Objection to Paling Yards Wind Farm | SSD-29064077

- 2. We are instructed to submit the following submission in relation to State significant development application number SSD-29064077 lodged by Global Power Generation Australia Pty Ltd (**the Proponent**) for the development of a wind farm with up to 47 wind turbines and associated infrastructure at several lots which form separate land holdings known as 'Mingary Park', 'Paling Yards', 'Middle Station' and 'Hilltop' in the Oberon Local Government Area (**the Project**).

(LVIA, Figure 11, Preliminary Assessment Tool 1, page 38).

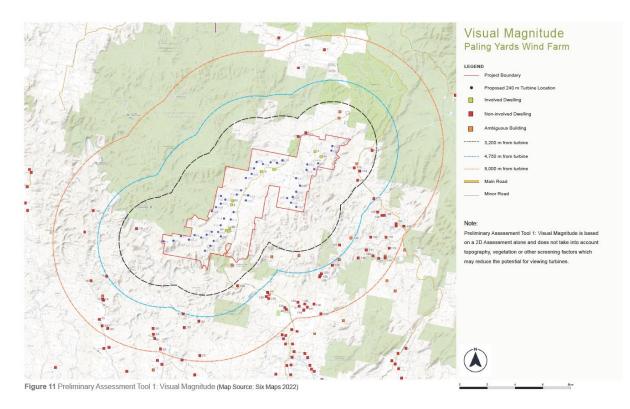
- Our clients purchased Highland Views in 2003. Highland Views is a small, recreational rural property, comprising 128 hectares, that benefits from views of the Great Dividing Range and Rolling Hills.
- 8. Unlike most nearby large rural grazing properties, Highland Views is one of the smaller parcels of land in the locality. Notwithstanding, Highland Views features one of the more substantial dwellings of the properties along The Levels Road. Our clients intend to soon retire and permanently reside at Highland Views.
- 9. Our clients' property is identified as non-involved Dwellings 17 and 18 in the LVIA Figure 11, an extract of which is below:
